ADA Curb Ramp New Construction Inspection Form (Parallel)

NW Timeric

23885.56

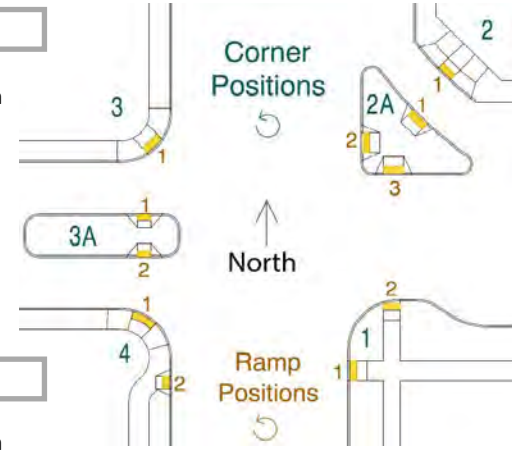
NTD RR1 TS Fail
